May 16, 2016

Re: Florida Power & Light Company
Proposed Turkey Point Units 6 and 7
Docket Nos. 52-040 and 52-041
Voluntary Submittal of Exemption Request and Design Change Description
for Departure From AP1000 DCD Revision 19 to Address
Main Control Room Dose Analysis

Departure Number	Departure Description Summary	FSAR Section or Subsection
PTN DEP 6.4-1	The main control room habitability system design and operator dose evaluation has been revised. Shielding was added to control room VES filter, VBS signals were added, VES actuation setpoints were adjusted to meet design requirements and allowable secondary iodine activity level was lowered. The following are the departures from the DCD: Tier 1 Subsection 2.2.5, Tier 1 Table 2.2.5-1, Tier 1 Table 2.2.5-5, Tier 1 Subsection 2.7.1, Tier 2 Table 1.6-1, Subsection 1.9.4.2.3, Appendix 1A, Subsection 3.1.2, Subsection 6.4, Subsection 6.4.2.6, Subsection 6.4.3.2, Subsection 6.4.4, Table 6.4-2, Subsection 7.3.1.2.17, Subsection 9.2.6.1.1, Subsection 9.4.1.1.1, Subsection 9.4.1.1.2, Subsection 9.4.1.2.1.1, Subsection 9.4.1.2.3.1, Figure 9.4.1-1 (Sheet 5 of 7), Table 11.1-4, Table 11.1-5, Table 11.1-6, Subsection 11.5.1.1, Subsection 11.5.

Figure 9.4.1-1R Nuclear Island Non-Radioactive Ventilation System Piping and Instrument Diagram

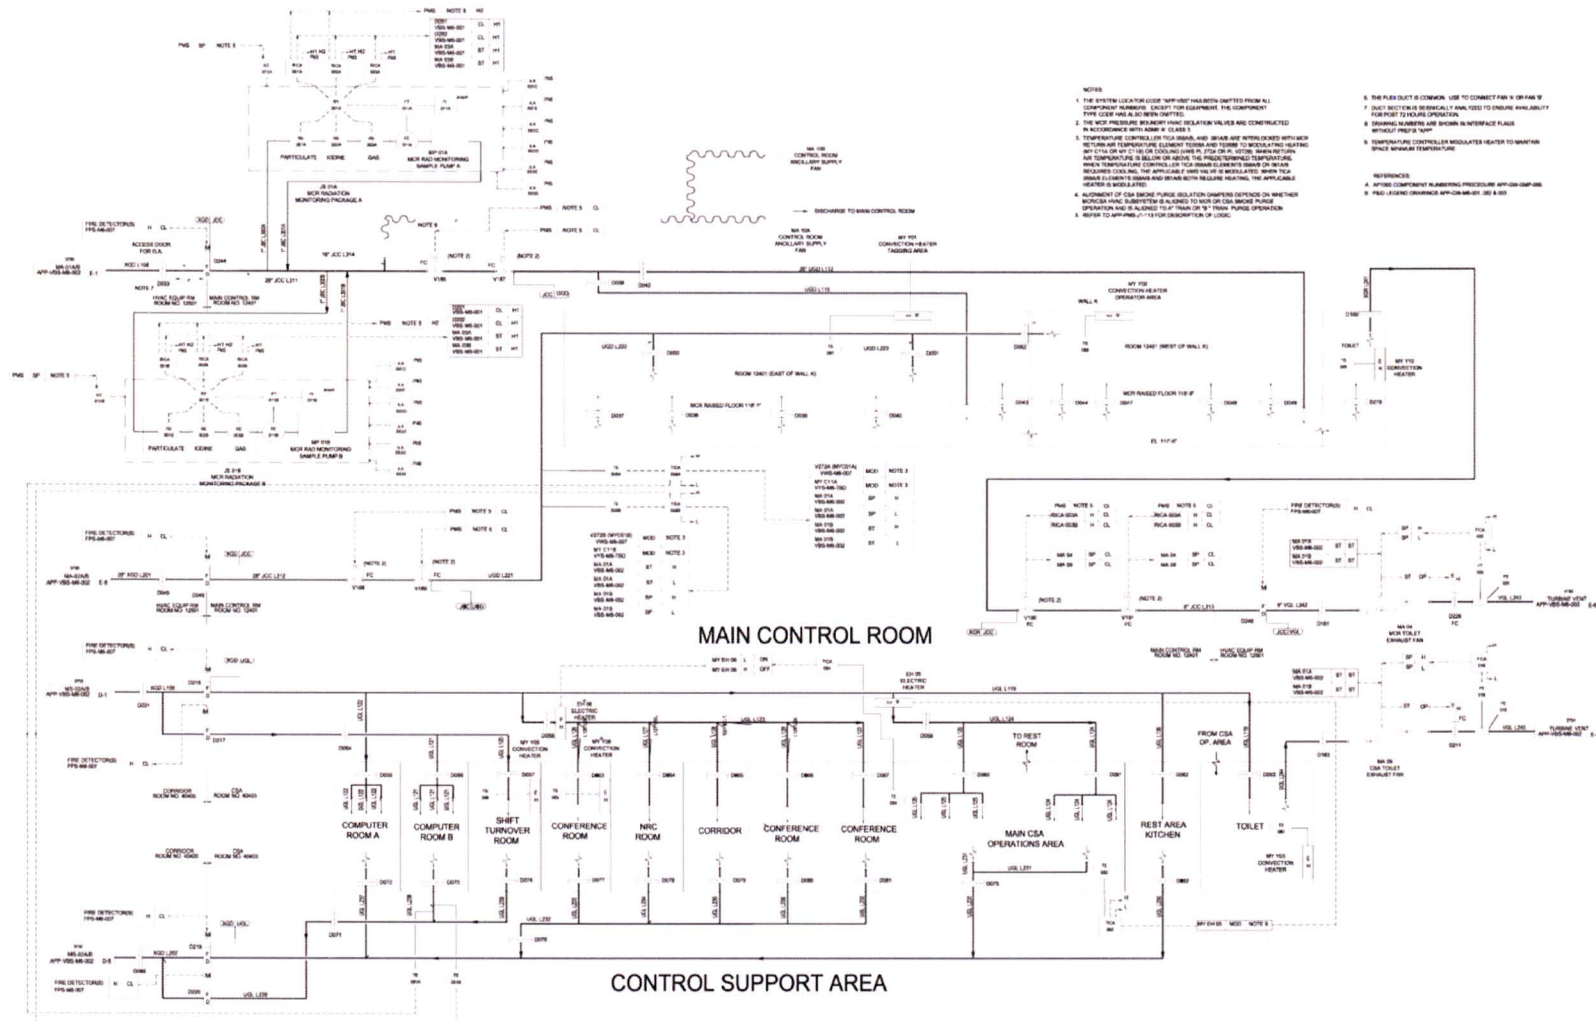
18. COLA Part 2, FSAR Chapter 9, FSAR Figure 9.4.1-1R is added with annotation PTN DEP 6.4-1 as follows (departure from DCD Figure 9.4.1-1 (Sheet 5 of 7))

If ac power is unavailable for more than 10 minutes or if "High-2" particulate or iodine radioactivity is detected in the main control room supply air duct, which would lead to exceeding GDC-19 operator dose limits, the protection and safety monitoring system automatically isolates the main control room from the normal main control room/control support area HVAC subsystem by closing the supply, return, and toilet exhaust isolation valves.

FIGURE 15.4.8-1R
NUCLEAR POWER TRANSIENT VERSUS TIME FOR THE PCMI ROD EJECTION
ACCIDENT

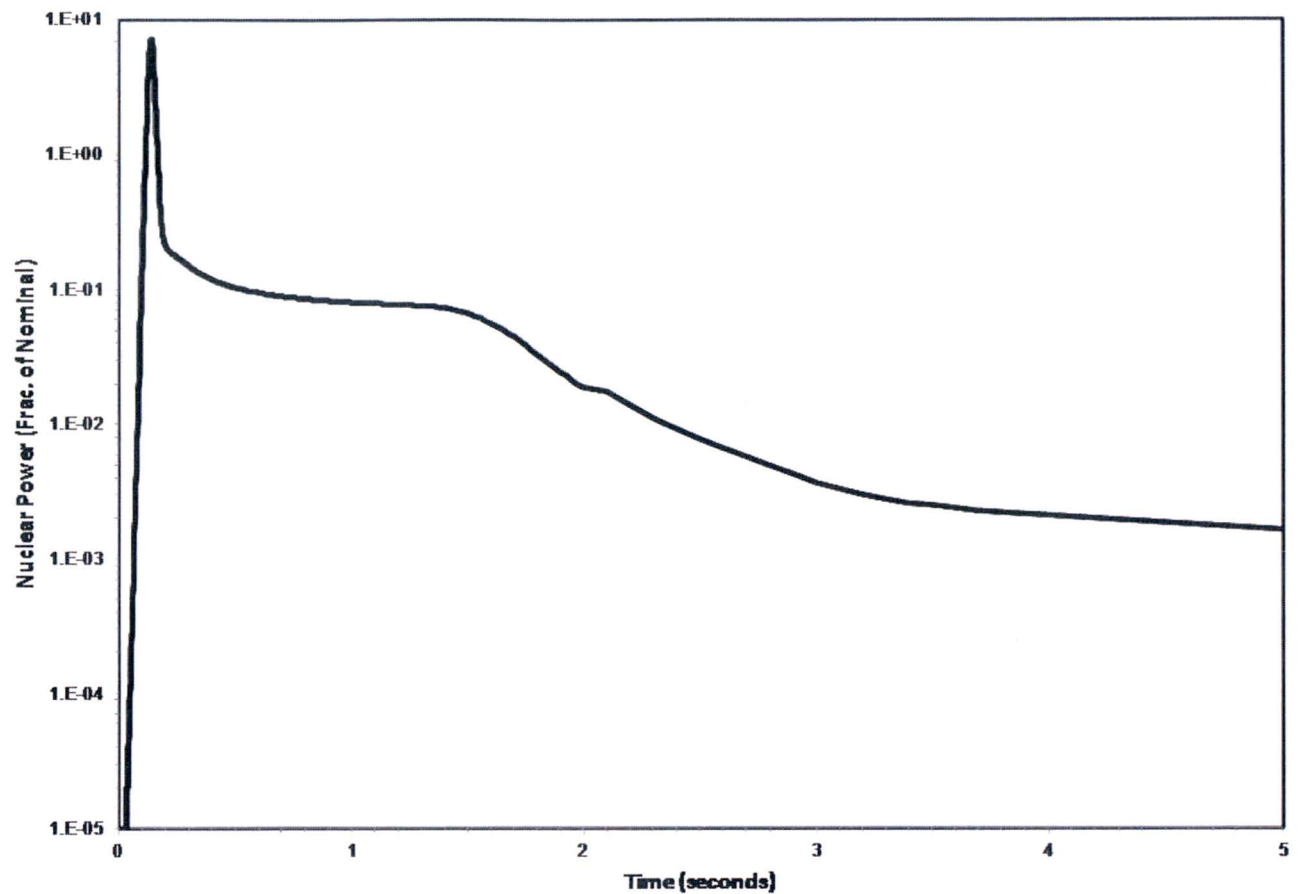
62. COLA Part 2, FSAR Chapter 15, Figure 15.4.8-1R is added with annotation PTN DEP 6.4-1 as follows (departure from DCD Figure 15.4.8-1):

FIGURE 15.4.8-2R
NUCLEAR POWER TRANSIENT VERSUS TIME
FOR THE HIGH CLADDING TEMPERATURE ROD EJECTION ACCIDENT

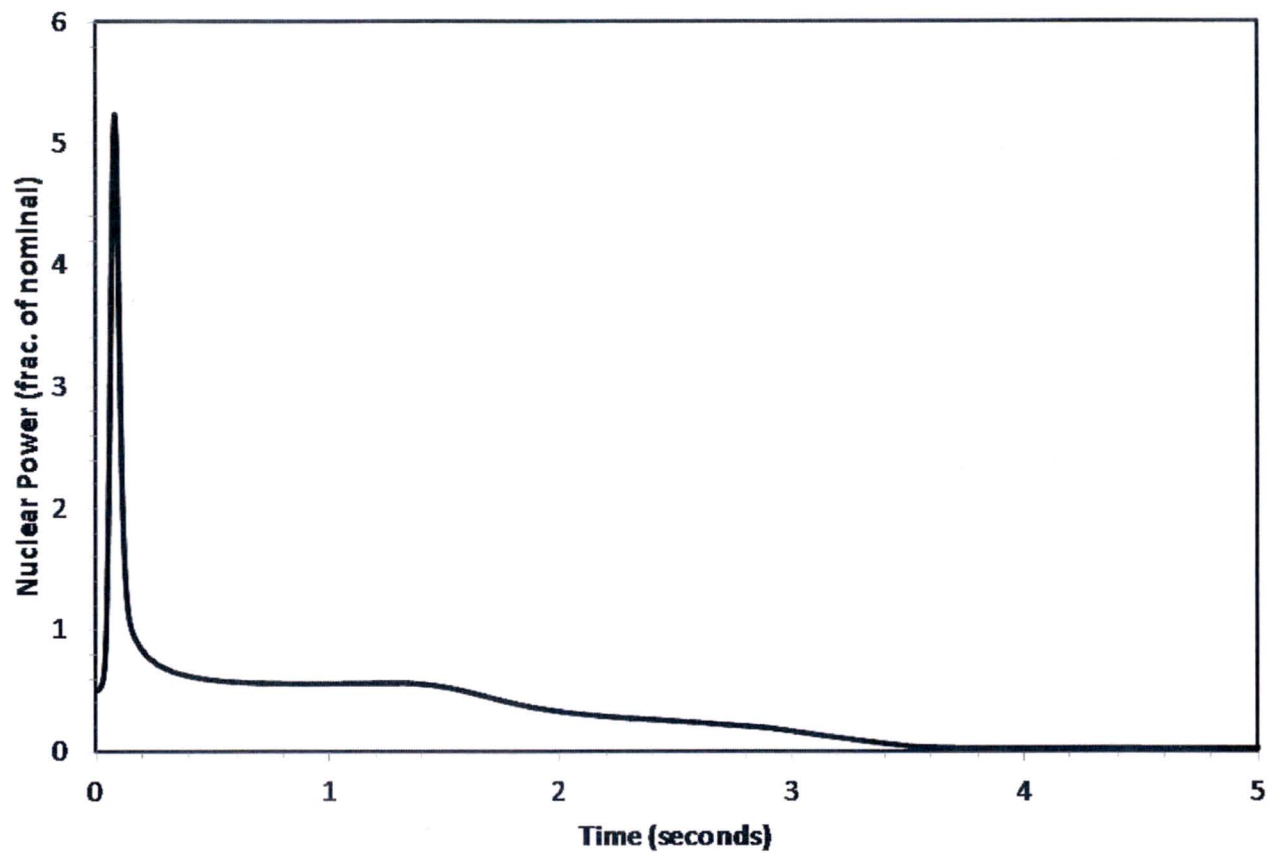
63. COLA Part 2, FSAR Chapter 15, Figure 15.4.8-2R is added with annotation PTN DEP 6.4-1 as follows (departure from DCD Figure 15.4.8-2):

FIGURE 15.4.8-3R

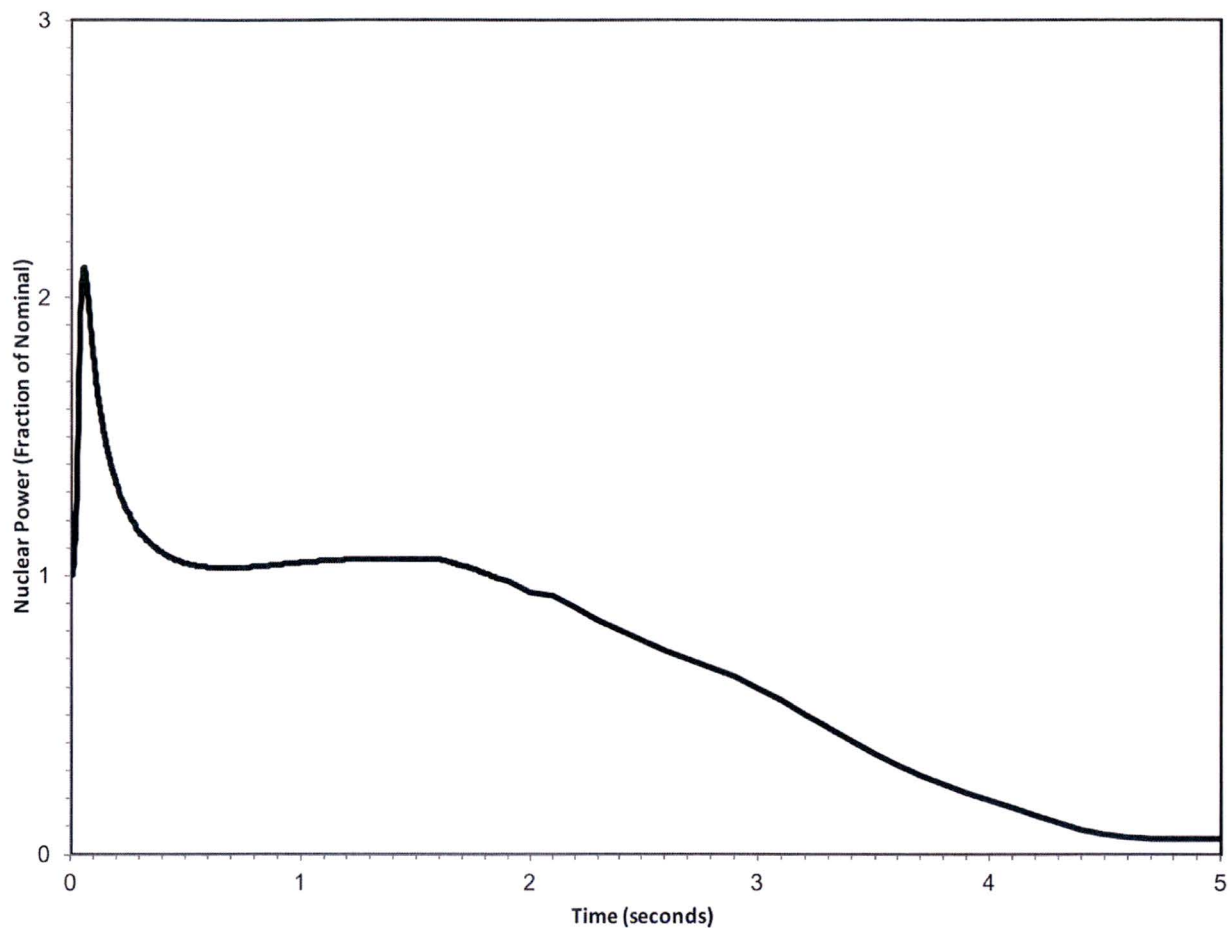
64. COLA Part 2, FSAR Chapter 15, Figure 15.4.8-3R is added with annotation PTN DEP 6.4-1 as follows (departure from DCD Figure 15.4.8-3):
